Technical Bulletin L53

Product: DVD Receiver

Hardware Technical Bulletin: L53-H2005-01

Subject: SRS Distortion

Figure 1 (schematic of Audio board)

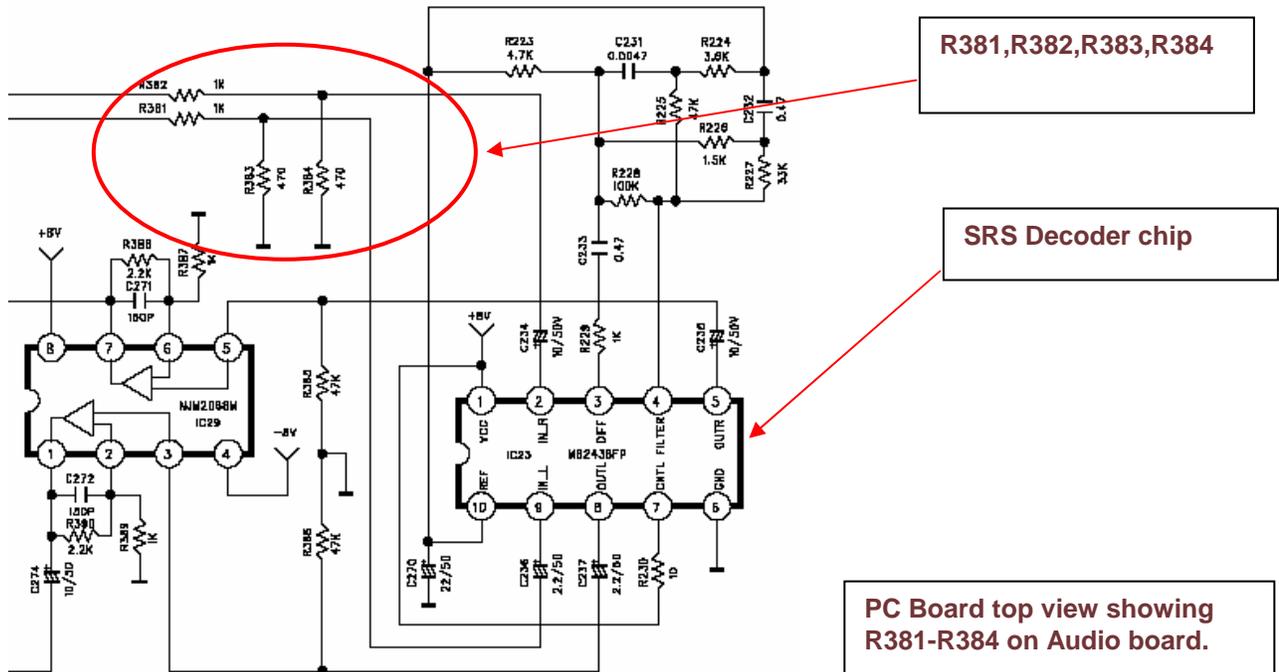
DESCRIPTION: In SRS mode when playing certain CD's and some DVD'S distortion can be heard coming from the speakers.

REASON: The input level to the SRS decoder chip is to high.

SOLUTION: In figure 1 the red circle is the part of the circuit to change. R383 and R384 are 470 ohms. By lowering these resistor values , distortion in SRS mode will be corrected.

The resistors that require lowering are R383 and R384 , 470 ohms each. The addition of another 470 ohm resistor in parallel with each resistor will give an overall resistance of 235 ohms each.. To do this lift the board and turn over to access the foil side . Mount the two resistors (470 ohm 1/6w) from the negative side of C234 and C236. to ground at pin-1 on BN23. See figure 4 .

Figure 2

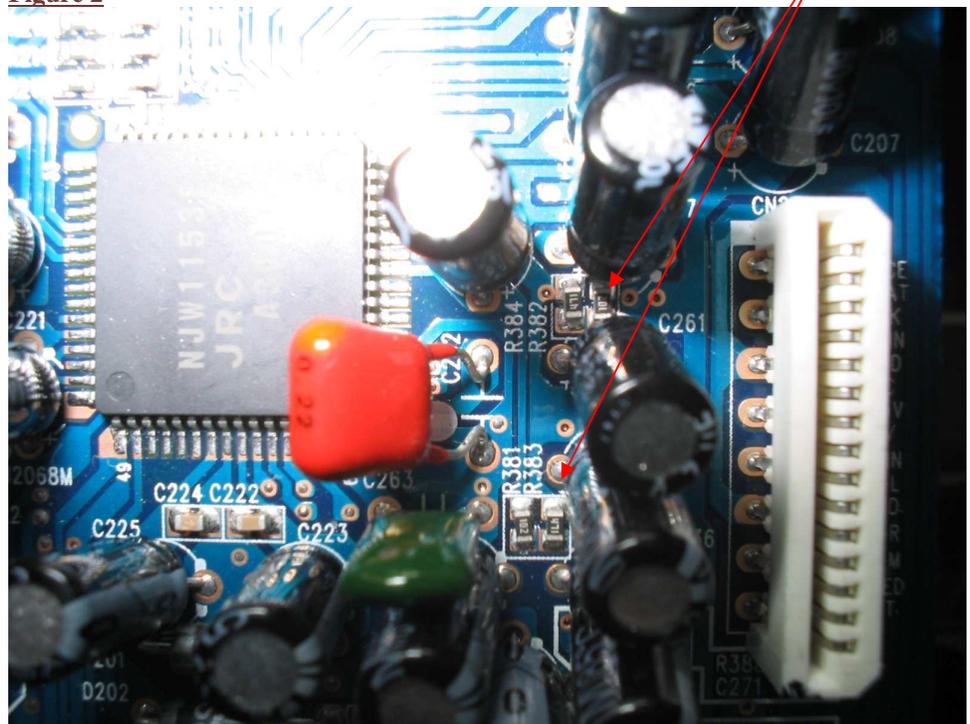
On the component side of the Audio board locate surface mount chip resistors R381 and R382. Check that their value is 1k ohm each. See figure 1 and figure 2.

Figure 3

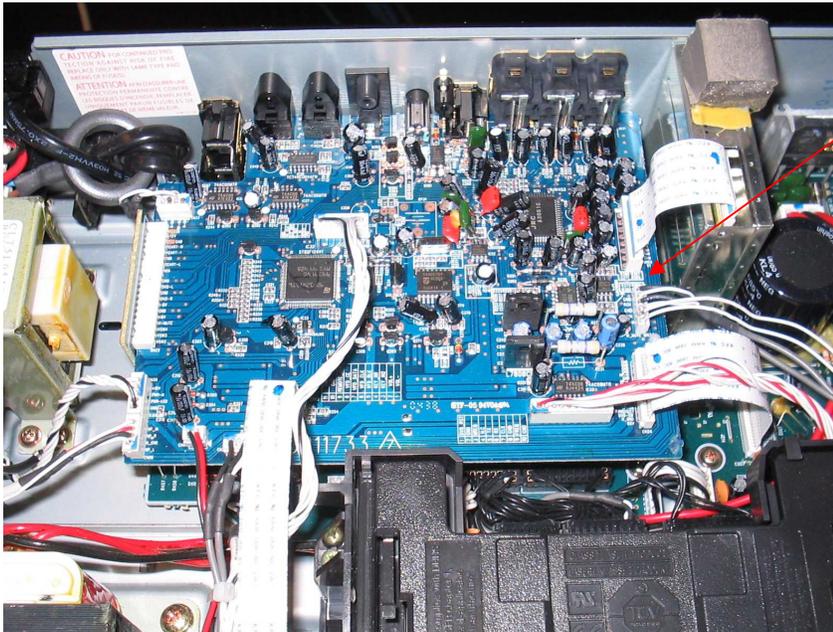
On the Audio board disconnect the tuner module flex cable CN22(see figure 3.) Main board flex cable (CN24), SPDIF harness (CN33) , and connector board (BN25/26). Remove the 6 screws from the back panel securing the Audio board.

Figure 4

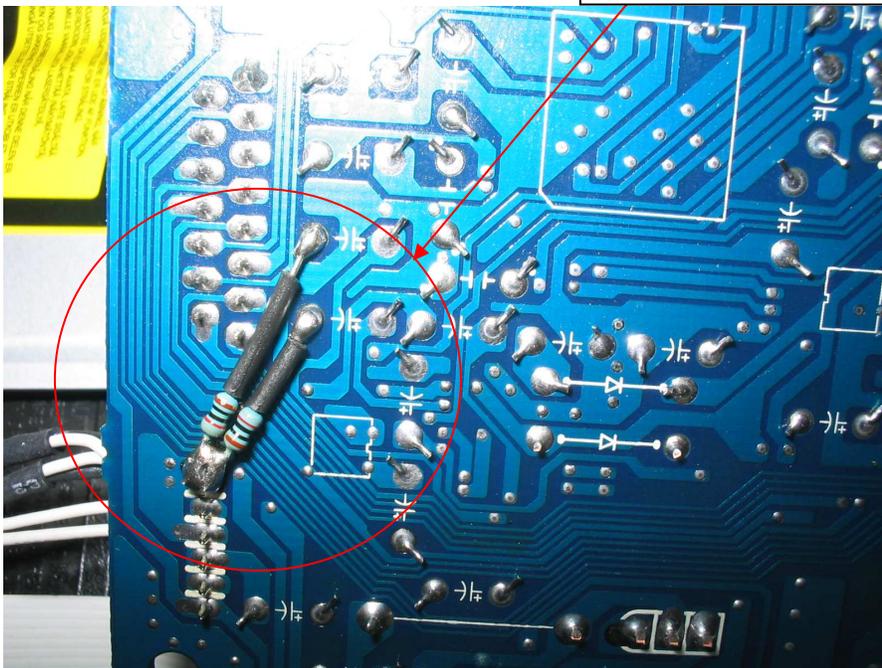
Bottom of Audio board showing addition of 470 ohm resistors
